In the Office Action dated February 13, 2002, all of the claims (1 - 31) were rejected under 35 U.S.C. § 103. By this amendment, Applicants have amended the drawings and the specification to correct several typographical errors.

Amendments to the Drawings

The drawings have been amended to correct several typographical errors in the drawings and a few omissions in the drawings. The majority of these errors involve the use of the same reference numeral for different elements in the drawings. No new matter has been added.

FIG. 1

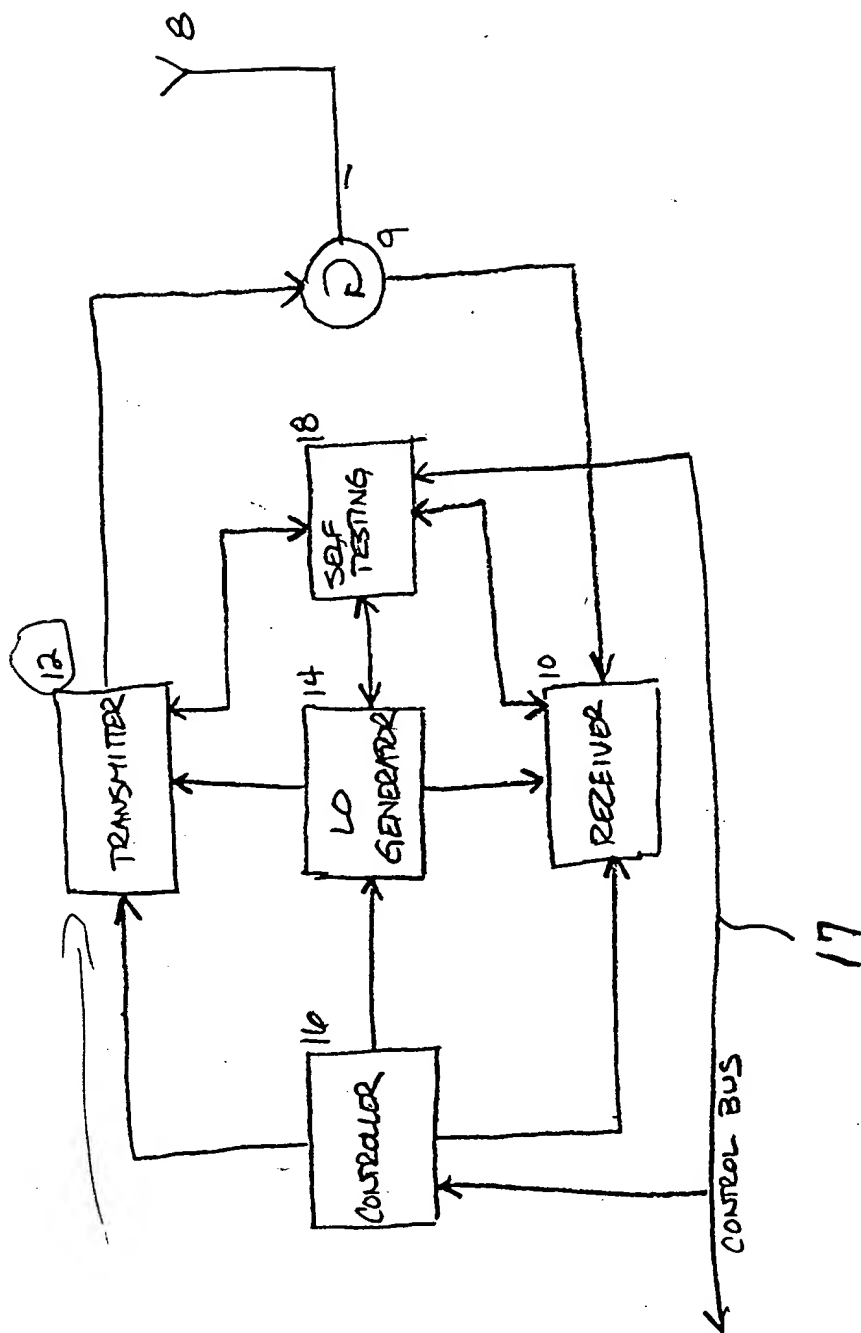
Figure 1 has been amended to add reference designation 17 to the control bus. This is supported in the specification, for example, at page 11, line 14: "control bus 17."

Fig. 2

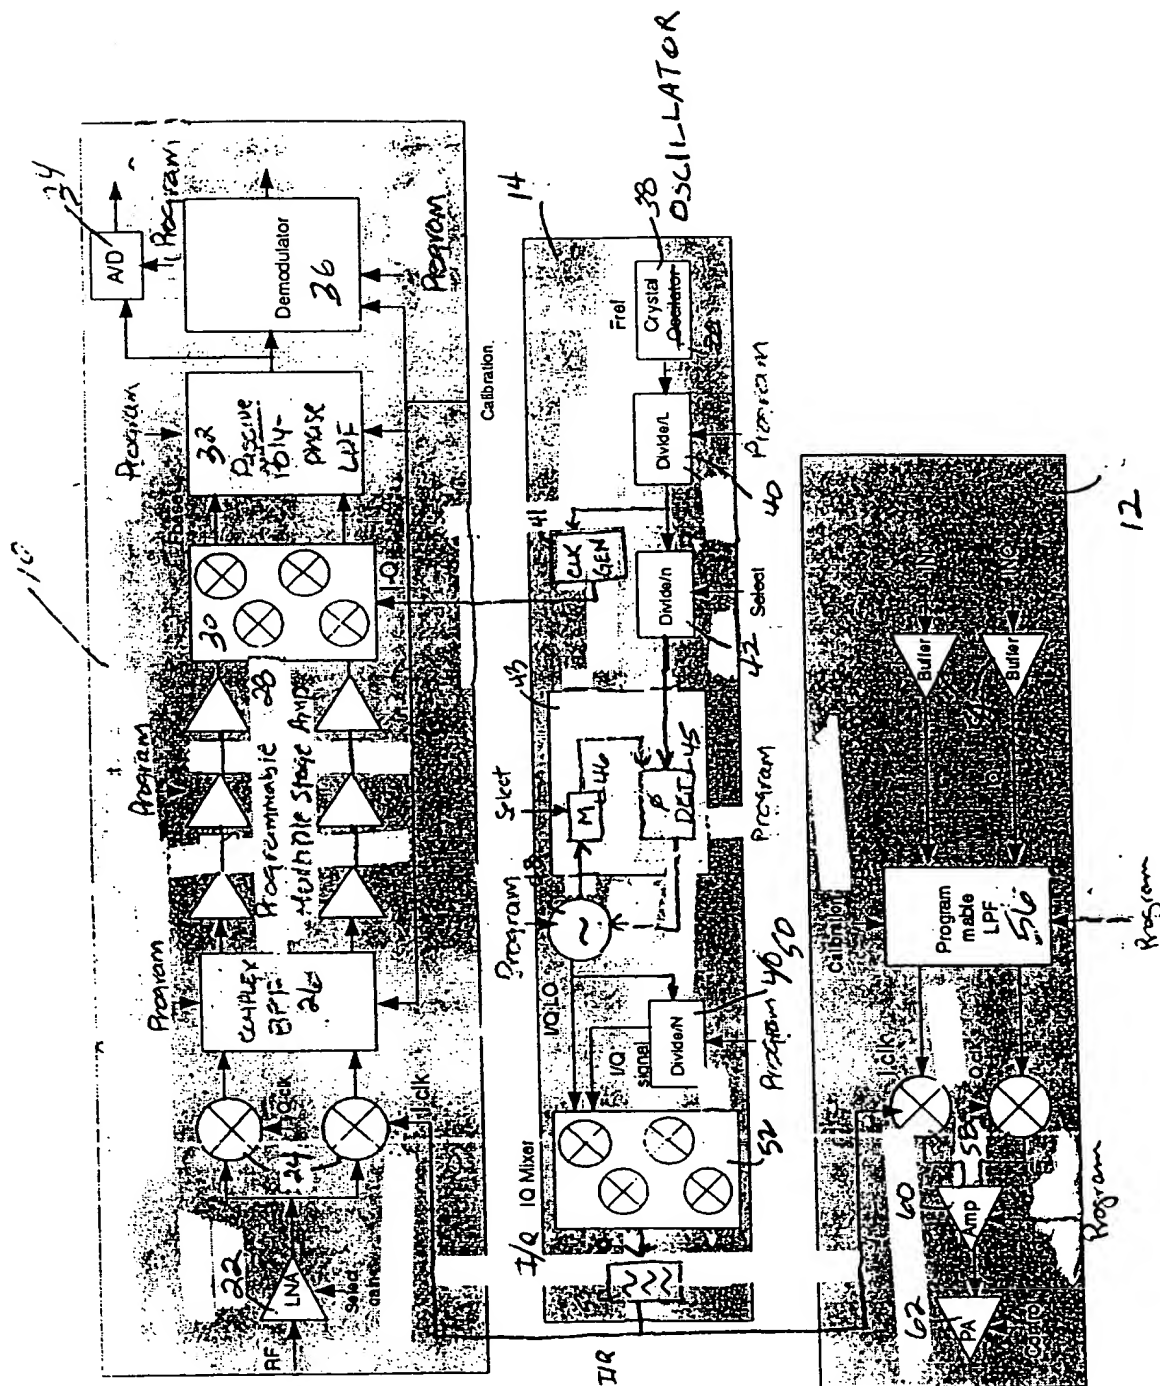
Figure 2 has been amended as follows:

A line has been added between components 52 and 53. This is supported in the specification, for example, at page 14, lines 29 - 30 where is explained that the output of the mixer 52 goes to the filter 53: "A filter 53 can be positioned at the output of the complex mixer."

The line added between components 52 and 53 is labeled "I/Q." This is supported in the specification, for example, at page 15, lines 19 - 22, where it is explained that the output of the mixer 52 may be an I/Q signal: "... the mixer 52 can be configured as a double quadrature mixer ... to generate the Q-clock and ... the I-clock."

A spelling error has been corrected in the label for the crystal oscillator 38.

The reference numeral 40 for the "DIVIDE / N" component has been corrected to designate reference numeral 50. This is supported in the specification, for example, at page 14, line 27: "divide by N circuit 50."

FIG. 4

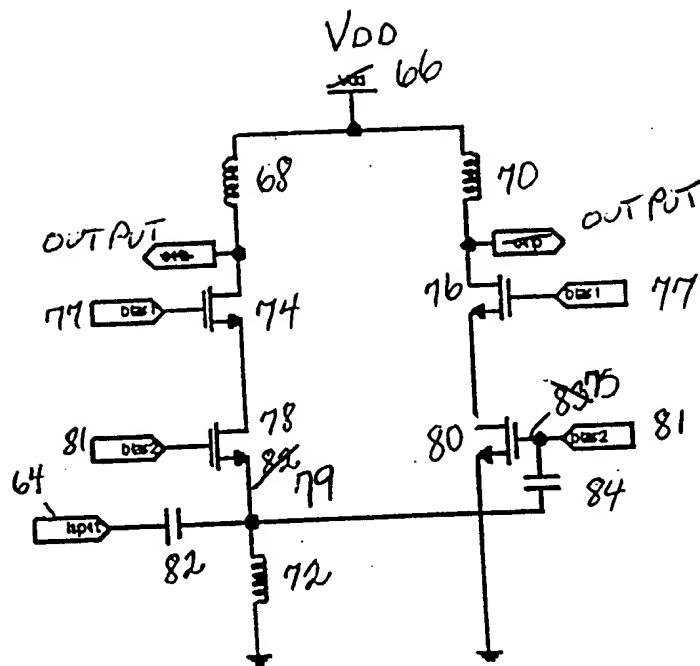
Figure 4 has been amended as follows:

Reference numeral 82 has been changed to 79.

Reference numeral 83 has been changed to 75.

These reference numerals have also been changed in the specification at page 18, lines 12 and 15 as set forth in the "**Version with markings to show changes made.**". These changes were made to correct duplicate use of the reference numerals 82 and 83.

The abbreviation "OUTP" has been changed to the complete word "OUTPUT."

FIG. 4(a)

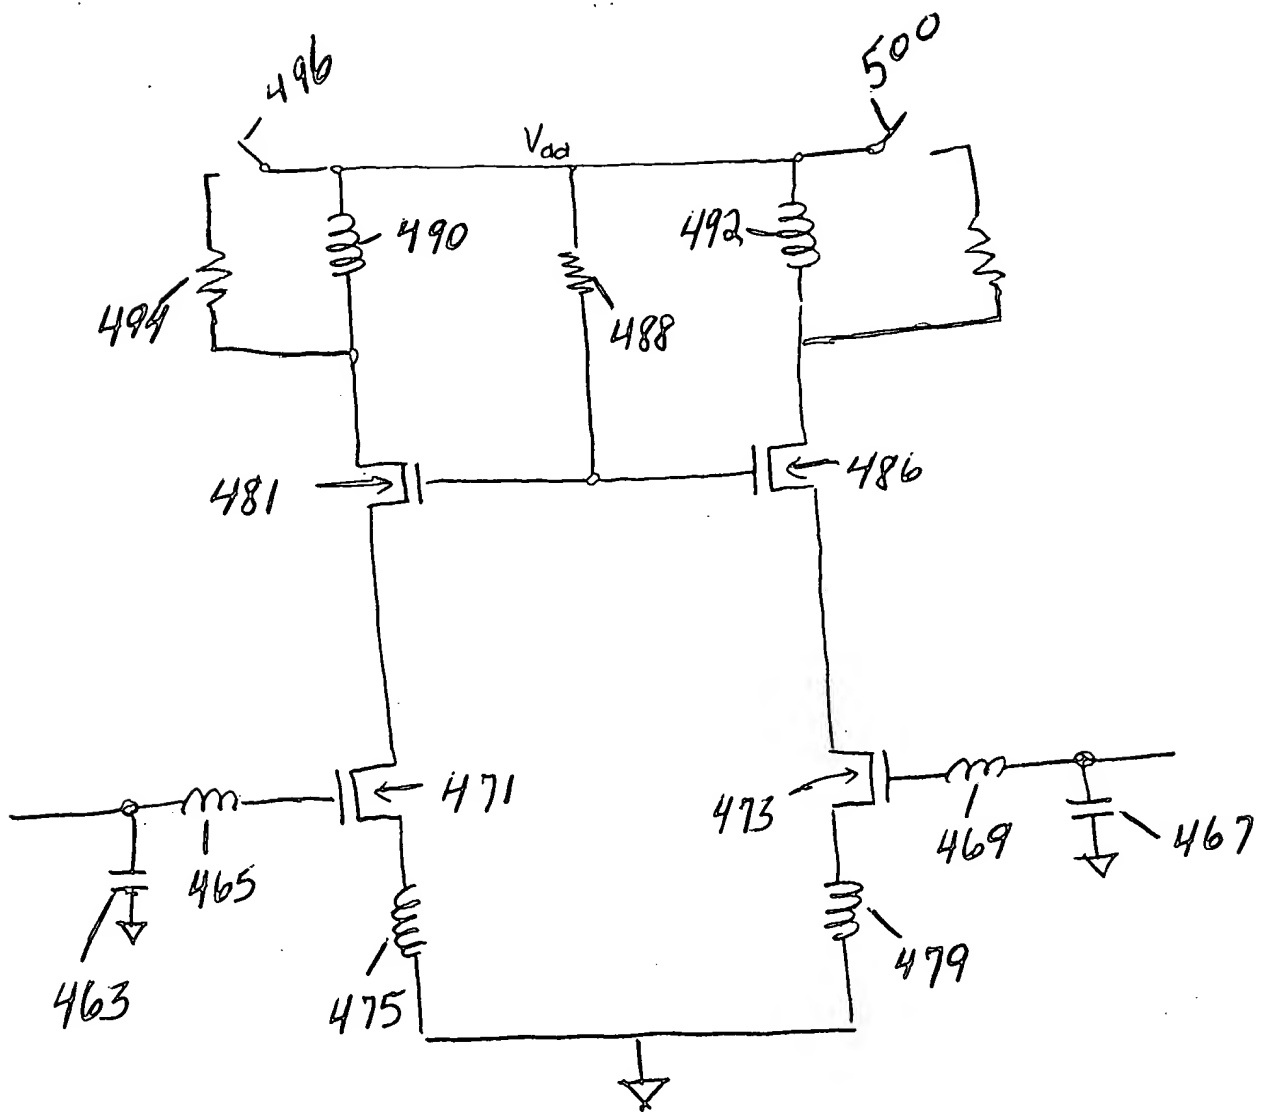
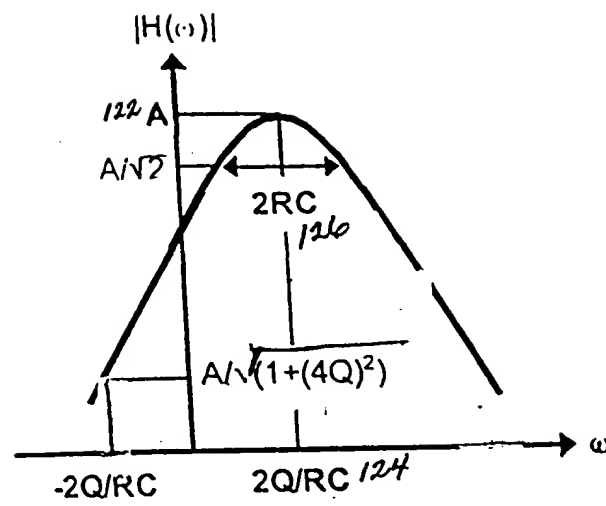
**Figure 4(a)** has been amended to add all of the reference numerals and to add four components.

The following reference numerals have been added: 463, 465, 467, 469, 471, 473, 475, 479, 481, 486, 488, 490 and 492.

The following components have been added: 494, 496, 498 and 500.

These reference numerals and components were inadvertently omitted from the drawing for Figure 4(a), however, these numerals and components are clearly described in the specification as being in Figure 4(a).

FIG. 14

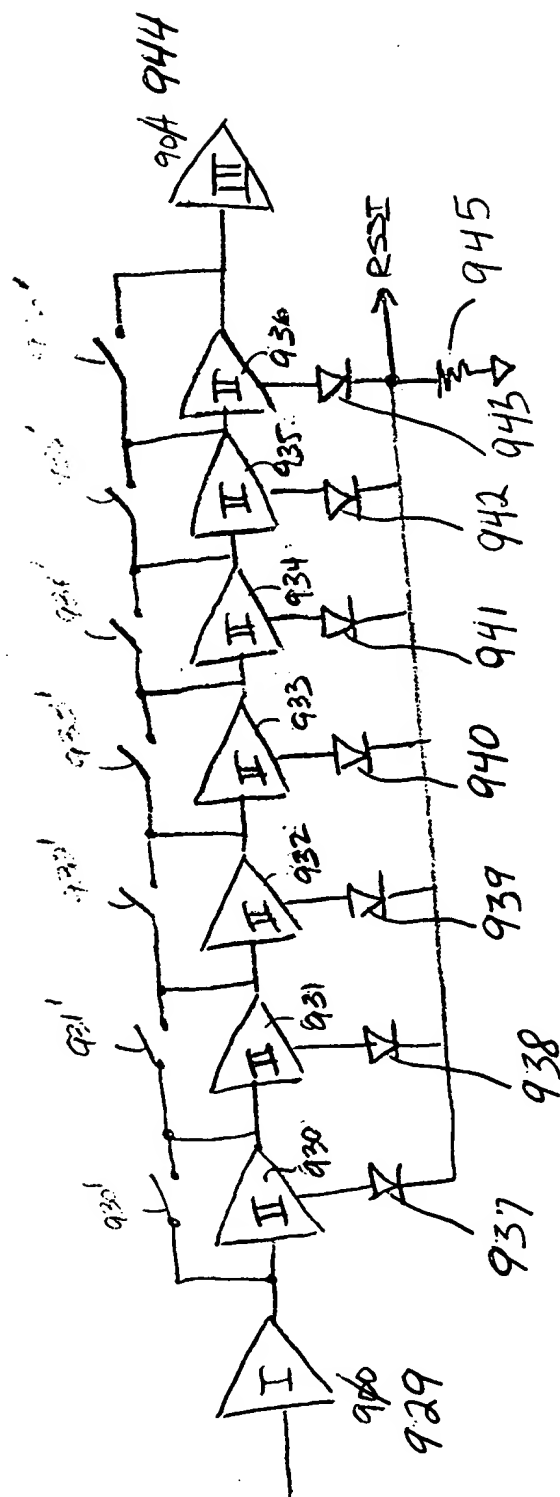
Figure 14 has been amended as follows:

Reference numeral 900 has been changed to 929. Reference numeral 904 has been changed to 944. These reference numerals have also been changed in the specification at page 32, line 8. These changes were made to correct duplicate use of the reference numerals 900 and 904.

The following reference numerals have been added: 937, 938, 939, 940, 941, 942, 943 and 945. These reference numerals were inadvertently omitted from the drawing for Figure 14, however, these numerals are clearly described in the specification as being in Figure 14. See, for example, page 33, lines 4 - 7: “The voltage at the output of each differential amplifier 930, 931, 932, 933, 934, 935, 936 is coupled to a rectifier 937, 938, 939, 940, 941, 942, 943, 944, respectively. The outputs of the rectifiers are connected to ground through a common resistor 945.”

FIG. 17(a)

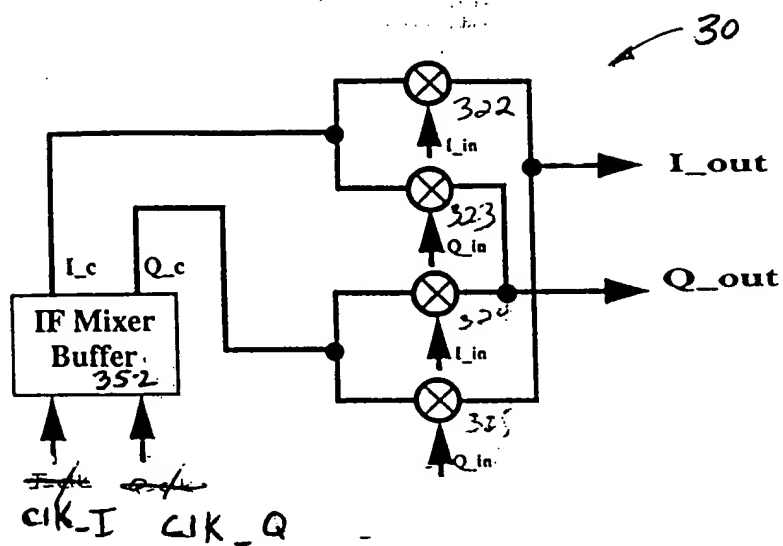
Figure 17(a) has been amended to change the labels I\_clk and Q\_clk to clk\_I and clk\_Q, respectively. This is supported in the specification, for example, at page 43, lines 31 - 32 where it is explained that the names of the input signals for the IF MIXER BUFFER 352 are clk\_I and clk\_Q: “The clock generator outputs clk\_I and clk\_Q for the IF mixer buffer (see figure 17).”

FIG. 23

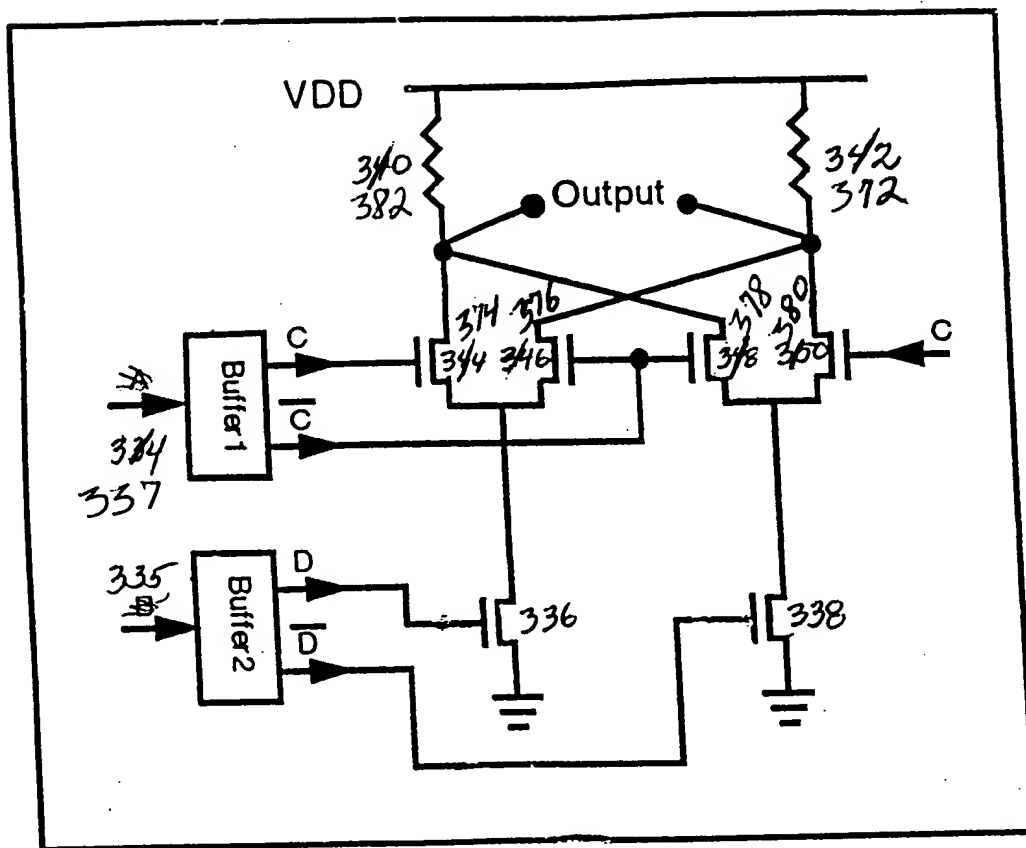
Figure 23 has been amended to correct duplicate use of the reference numerals 334, 340, 342, 344, 346, 348 and 350.

Reference numeral 334 has been changed to 337.

Reference numeral 340 has been changed to 382.

Reference numeral 342 has been changed to 372.

Reference numeral 344 has been changed to 374.

Reference numeral 346 has been changed to 376.

Reference numeral 348 has been changed to 378.

Reference numeral 350 has been changed to 380.

FIG. 32

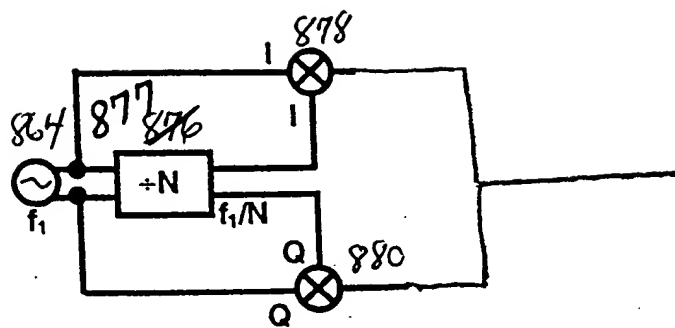
**Figure 32** has been amended to correct duplicate use of the reference numeral 876. Reference numeral 876 has been changed to 877. This reference numeral has also been changed in the specification at the paragraph beginning at page 55, line 5 as set forth in the **"Version with markings to show changes made."**

FIG. 33(a)

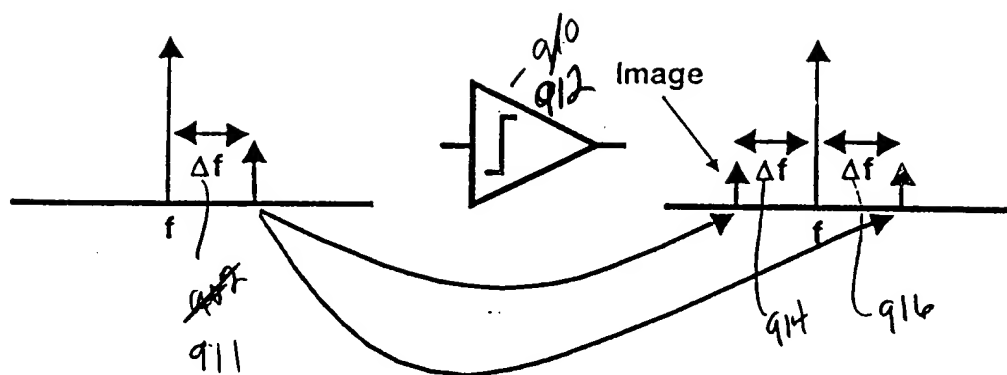
**Figure 33a** has been amended to correct duplicate use of the reference numerals 902 and 910.

Reference numeral 902 has been changed to 911.

Reference numeral 910 has been changed to 912.

FIG. 40

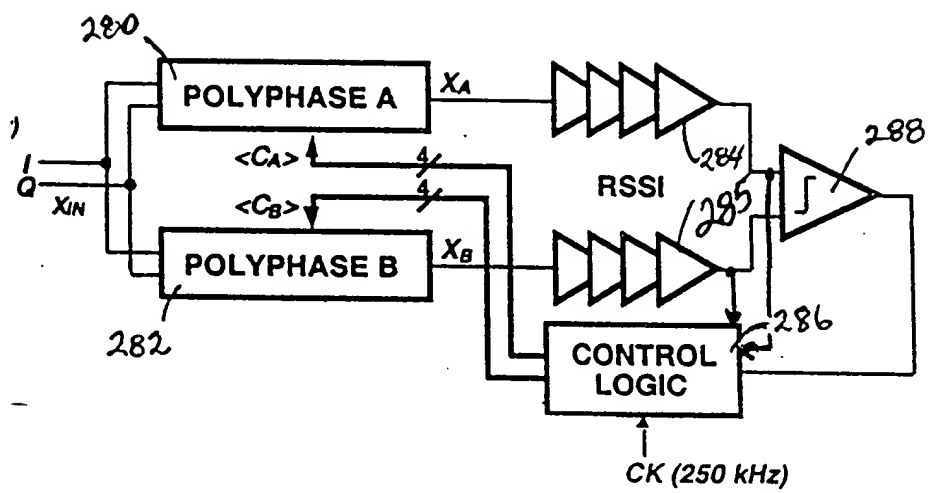
**Figure 40** has been amended to add reference numeral 285 that was inadvertently omitted from the drawing for Figure 40. As described, for example, at page 72, lines 25 - 26, reference numeral 285 is clearly described in the specification as being in Figure 40: "The signals at the outputs of the polyphase filters are detected with a received-signal-strength-indicator (RSSI) block 284, 285 in each path."

FIG. 45

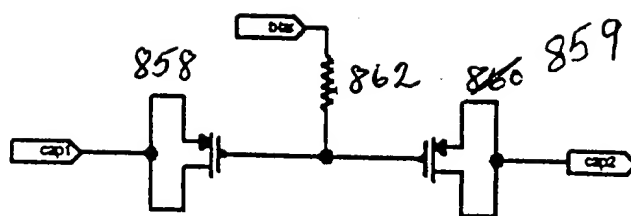
**Figure 45** has been amended to correct duplicate use of the reference numeral 860. Reference numeral 860 has been changed to 859. This reference numeral has also been changed in the specification at the paragraph beginning at page 78, line 15 as set forth in the "**Version with markings to show changes made.**"
